APPROVAL OF A CHANGE ORDER UNDER \$10,000.

I recommend that the Hardin County Board of Education approve change orders New Central Office Annex (1.1, 1.2, 1.3).

RE: Renovation of B & W Metals Building for Hardin County Board of Education 209 Corporate Drive Elizabethtown, Kentucky 42701 PFGW # 0804

1.1

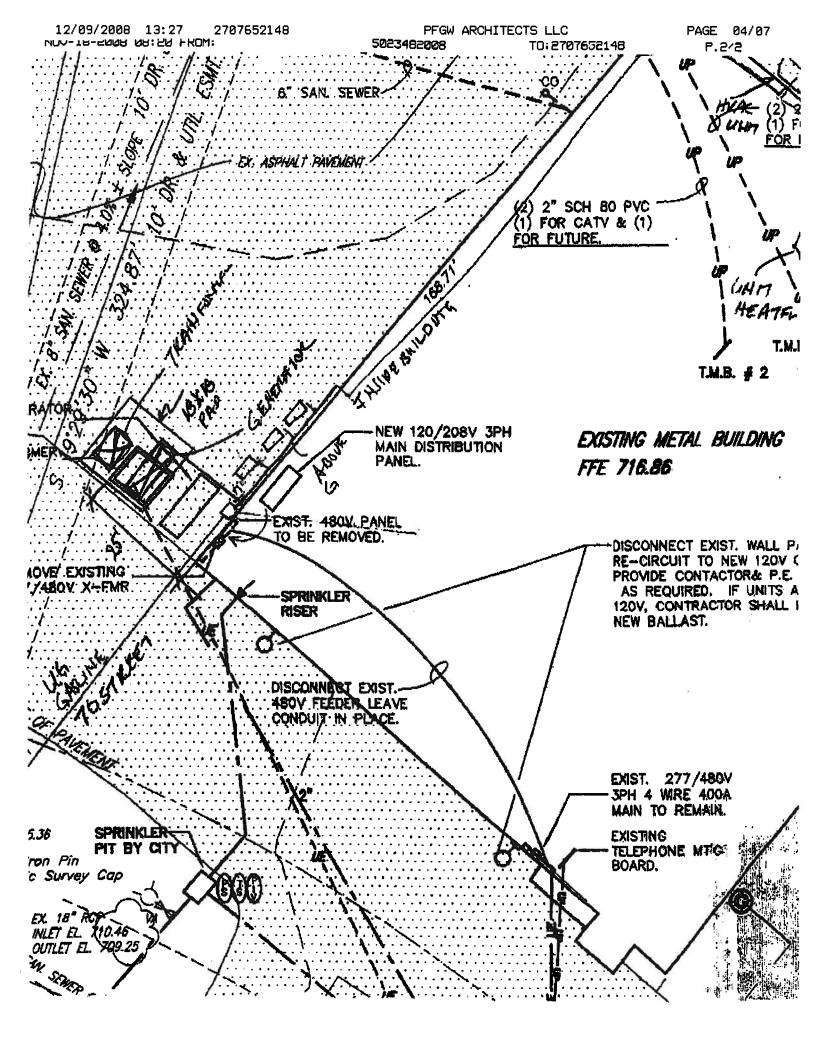
ATTACHED IS A SKETCH SHOWING THAT A 1" UNDERGROUND GAS LINE COMES FROM THE STREET TO A METER. OUT OF THE METER, WE WILL EXTEND A STEEL LINE, A 3" GAS LINE TO THE GENERATOR & A 2" GAS LINE TO THE IIVAC UNIT WHICH WILL BE REDUCED AS APPROPRIATE AS WE PASS EACH UNIT. ONCE WE GET PASS THE THREE UNITS THAT ARE ON THE GENERATOR SIDE OF THE BUILDING, WE WILL GO INSIDE THE BUILDING AND RUN TO THE BACK OF THE BUILDING TO ACCOMMODATE THE HVAC UNIT IN THE BACK OF THE BUILDING AND THE UNIT HEATER IN THE BACK OF THE BUILDING. IF YOU HAVE ANY QUESTION REGARDING THIS, PLEASE CALL.

PLEASE NOTE THAT THE GAS COMPANY HAS INDICATED THAT THERE IS PROBABLY GOING TO HAVE TO BE SOME KIND OF GUARDS FOR THESE GAS LINES RUNNING TO THE GENERATOR AND HVAC UNIT, BUT I DON'T KNOW WHAT THEY ARE GOING TO EXPECT UNTIL WE GET IT INSTALLED.

Site	Item	Reason for Change	Amount of Change
1.1	ANNEX	Add second gas meter and reroute gas line piping.	To accommodate the emergency generator the gas lines required resizing. The gas piping was sized to accommodate HVAC needs but not the emergency generator. Additional it was determined that a second gas meter would better serve the building needs.	\$6,181.38
